**Powerline along Coorow-Greenhead and
Cockleshell Gully Roads - through
Mount Lesueur National Park**

State Energy Commission of Western Australia

**Report and recommendations
of the Environmental Protection Authority**

**Environmental Protection Authority
Perth, Western Australia
Bulletin 641
August 1992**

Figure 3: The section of the Coorow-Greenhead Road with the most significant viewscape

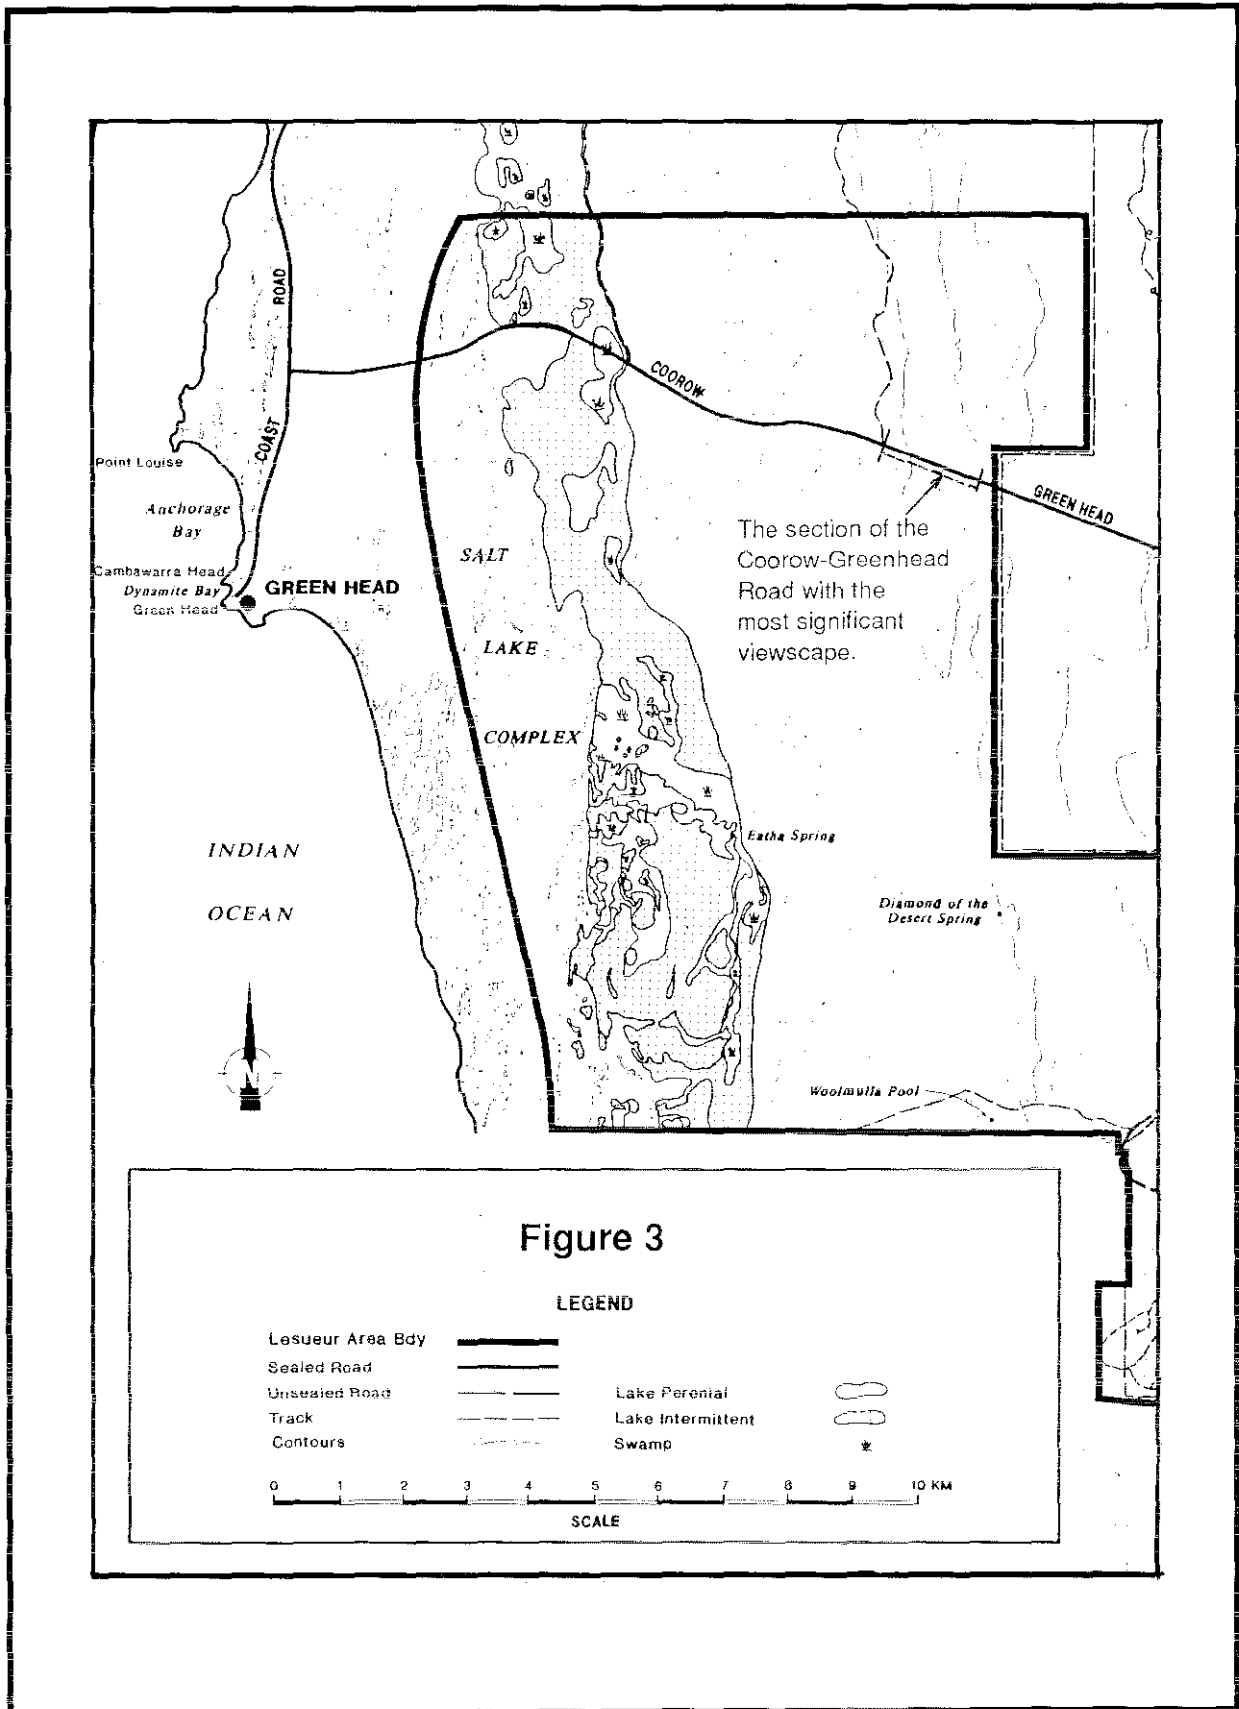
The Authority is of the view that the State Energy Commission of Western Australia should investigate this option thoroughly for the important area along the Coorow-Greenhead Road within the Mount Lesueur National Park (Figure 3). Only if placing the powerline underground is determined as being not feasible following the investigation, should it be considered acceptable for it to be placed above ground, subject to conditions. This is because there is the potential for net environmental benefits from putting all the services to the towns of Leeman and Greenhead in one corridor (viz. road, power, water and telecommunications), and removing and rehabilitating the other corridor through the Beekeepers Reserve.

The State Energy Commission of Western Australia thoroughly investigate the feasibility of constructing that portion of the powerline shown in Figure 3 underground in a trench shared with Telecom Australia. If feasible, then the powerline should be constructed underground at this location. If not feasible in the opinion of the Minister for the Environment and the Minister for Fuel and Energy, then the powerline could be constructed above ground subject to Recommendations 4 and 5 of this report, and subject to the State Energy Commission of Western Australia conducting a trial in another environmentally sensitive location where a high tension powerline is placed underground. That trial should be carried out within 18 months of any approval for this proposal, to meet the requirement of the Minister for the Environment and the Minister for Fuel and Energy.

FIGURE 3A

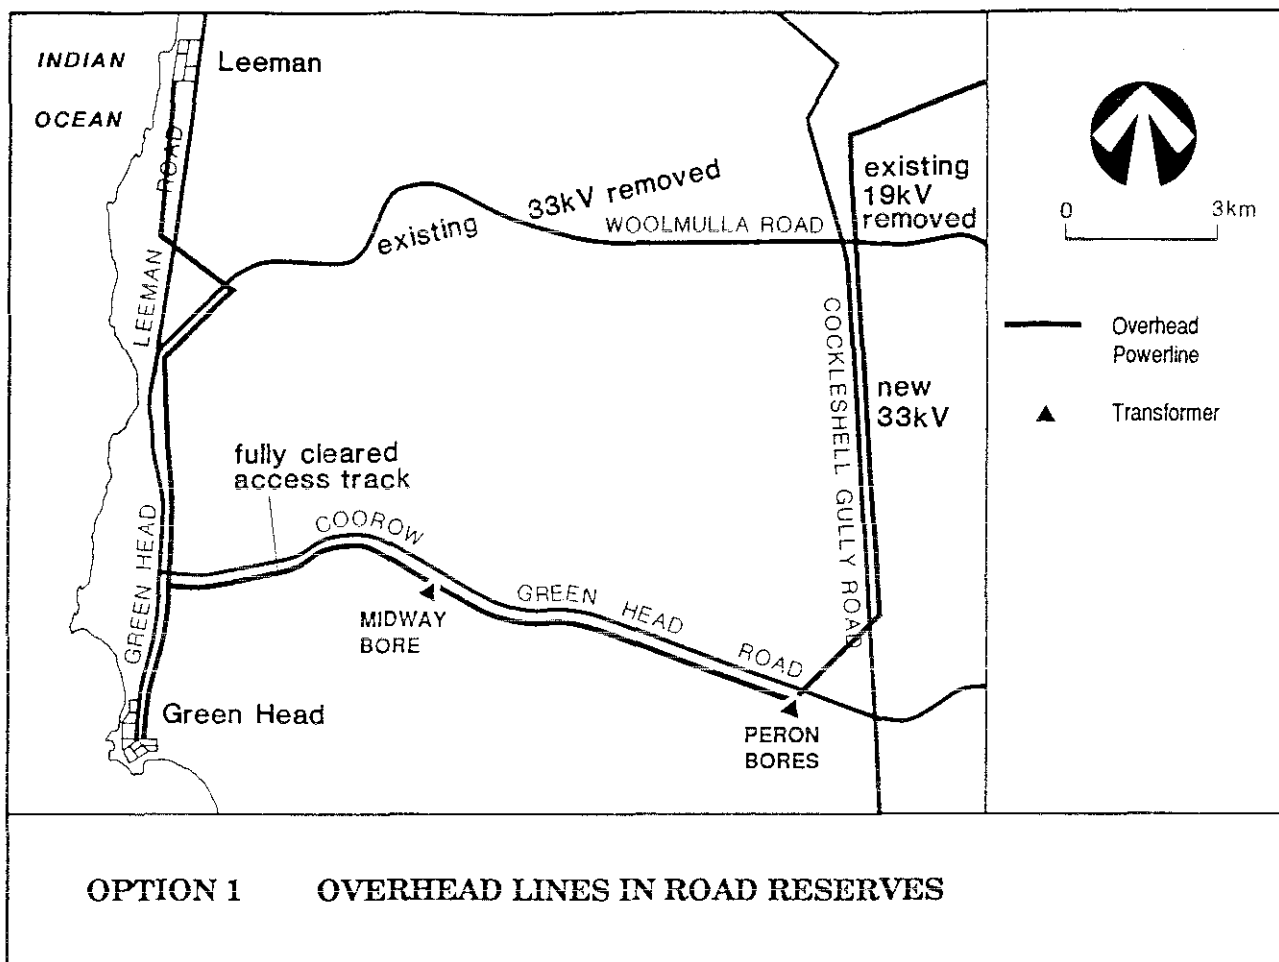
Figure 3a showing the preferred option indicates a fully cleared access track. This figure and any working plans should be altered in line with the commitment.
